SYDNEY CENTRAL PLANNING PANEL PANEL DETERMINATION MEETING

JRPP No	2017SCL028
DA Number	DA-13/135/06
Local Government Area	Bayside Council
Proposed Development	<p>Section 96AA Application to modify Development Consent No. 13/135 as follows:</p> <ul style="list-style-type: none"> • Amend the lift on the southern building to provide access to the rooftop common open space; • Increase the height of the lift overrun to RL 52.2 metres AHD; • Changes to the glass roof shape (lowered); • Amend Wind Impact Assessment and Landscape Co-ordination
Street Address	659, 661-663 & 669 Gardeners Road, Mascot
Applicant	Dedico Development Service
Owner	Mascot Circle Pty Ltd
Number of Submissions	Nil
Regional Development Criteria (Schedule 4A of the Act)	Section 96AA Application to modify a consent determined by the NSW Land and Environment Court, pursuant to Clause 21 of State Environmental Planning Policy (State and Regional Development) 2011
List of All Relevant s79C(1)(a) Matters	<ul style="list-style-type: none"> • List all of the relevant environmental planning instruments: s79C(1)(a)(i) <ul style="list-style-type: none"> ◦ State Environmental Planning Policy No. 65 – Design Quality of Resident

Figure 4. Proposed rooftop communal space on Northern Building

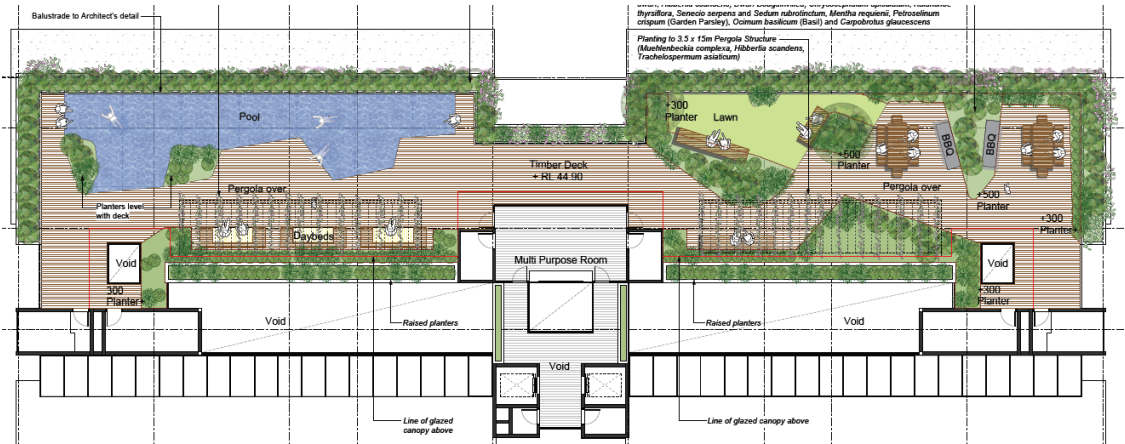
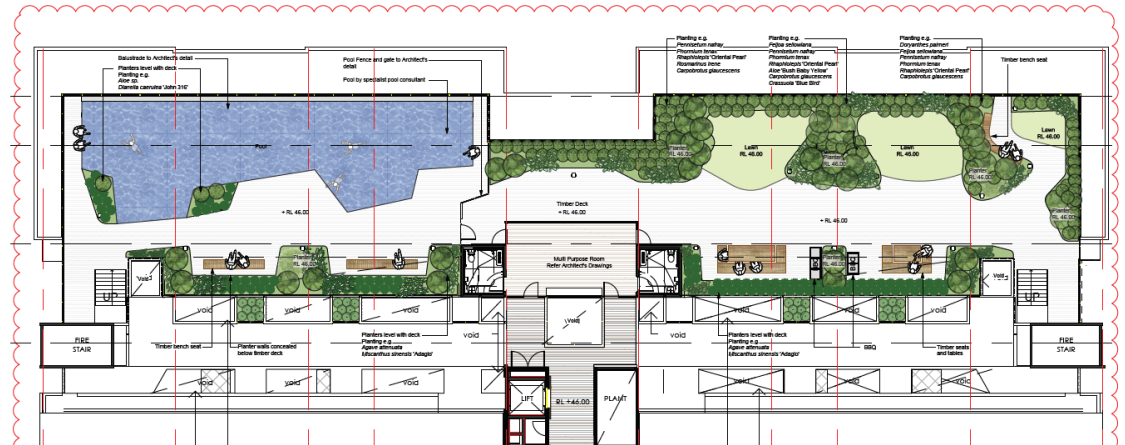
Modification No. 2: Deletion of the perimeter landscaping on the rooftop terrace

The proposed modification relates to the shifting of the approved glass balustrade around the perimeter of the building from a 1 metre distance to now being positioned at the edge of the building. The reason for this is that the proposed landscaped area

which was external to the balustrade would have been difficult to maintain. The figures below demonstrate the approved and proposed landscape plans showing the rooftop communal open space of both the Northern and Southern buildings:

A calculation of the landscaped area that was approved and proposed demonstrates that there has been no reduction in landscaping, rather it has been redistributed elsewhere on the rooftop. It is noted that the swimming pool on the Northern Building has been extended to the edge of the building and the landscaped area surrounding the pool has been removed. A number of the pocket landscaped areas have been slightly adjusted in size and location as well in addition to the BBQ area and tables relocated elsewhere. The pergolas on top of these tables have been removed. The development has a total of 2,918sqm or 33% as approved in the previous modification and this has not changed. Therefore the relocation of the balustrading is supported.

Figure 8. Proposed Roof Plan of Northern Building showing open pergolas and metal roof and remaining glazed canopy

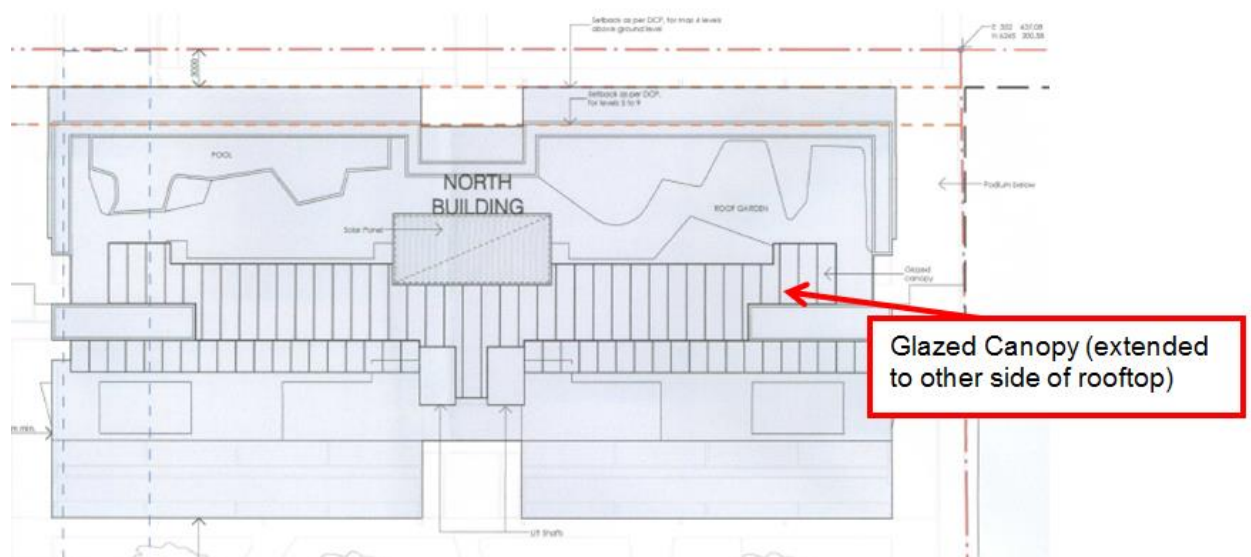
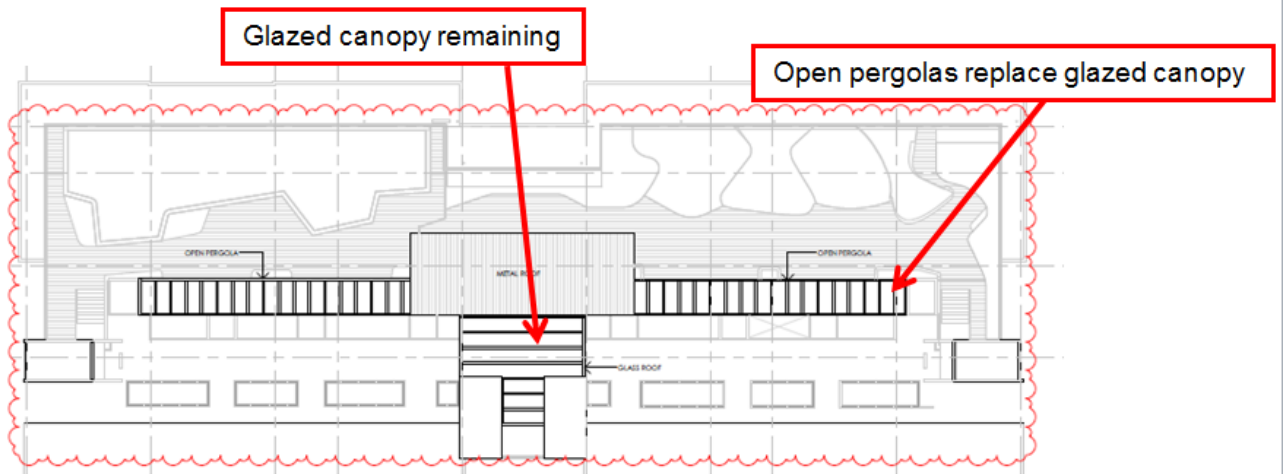
Modification No. 3: Changes to the glass roof shape (lowered) to both the North and South Tower to comply with the requirements of the fire engineering report

The modification proposes to amend the approved glazed canopies which covered a majority of the rooftop area over the void areas and the multi purpose room and lift access. The modification now proposes to reduce the size of the glazed canopies so that they cover the multi-purpose room and lift access area and the area that was originally covered by the glass canopy has now been amended to contain open pergolas. This is demonstrated in the figures below.

The amendments to this portion of the site are as required by the Fire Safety Engineer and fire engineering report. Due to the modifications to the glass canopy, the roof form has been amended to delete the approved glass atrium roof to a lower solid roof with skylights. Additionally, the glazed canopy that is now replaced by the open pergolas has been reduced in height. This will reduce the bulk and scale when viewed from the rooftop and from the streetscape. In the below figures, sections have been provided showing the change to the glazed canopies and the roof skylights.
